Product Change Notification

Products affected: All Aimtec AM1DS-NZ and AM1LS-NZ series components.

Current AM1LS-NZ case:

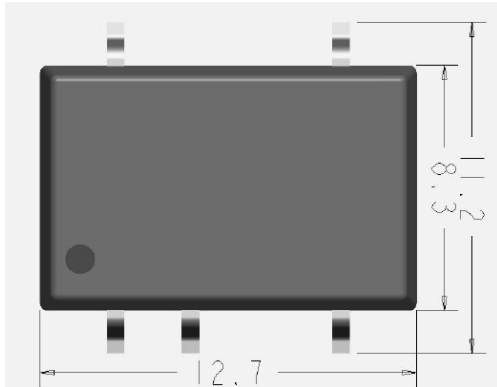
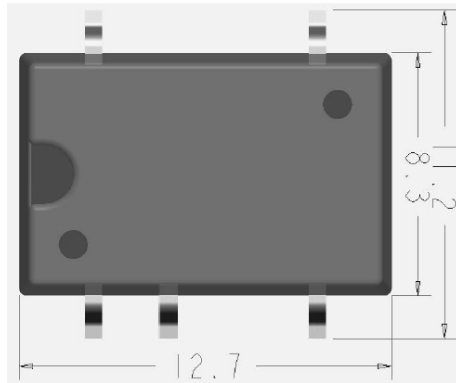
Description of change: Aimtec will be changing the plastic packaging material used to produce the cases on the above mentioned products to fully automate the manufacturing processes of plastic packaging, cutting, bending and tube packing equipment. Furthermore, there will be 2 polar points of AM1LS-NZ series plastic packaging with centralizing stopper on the first pin point side.

AM1LS-NZ case after this PCN's implementation:

Current AM1DS-NZ case:

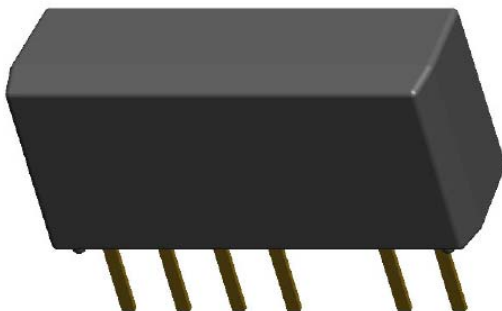
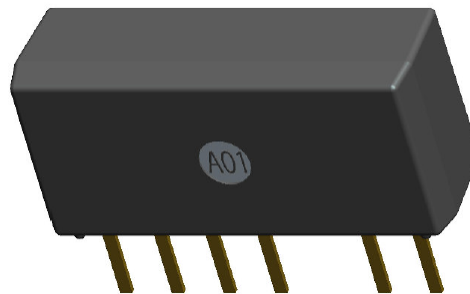
On the bottom of AM1DS-NZ series plastic case a new centralizing stopper will appear.

AM1DS-NZ case after this PCN's implementation:
